AMENDMENT NO. 1 MARCH 1989
TO
IS : 5445-1978 SPECIFICATION FOR LONG FLUTED MACHINE REAMER
WITH MORSE TAPER SHANKS
(First Revision)

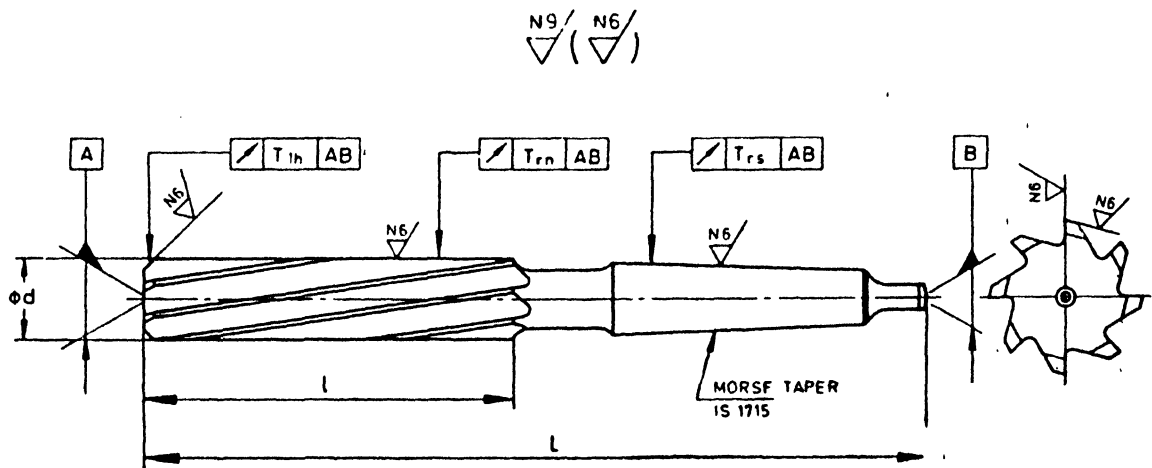
(Page 2, Table 1, Figure) — Substitute the following figure for the existing figure:
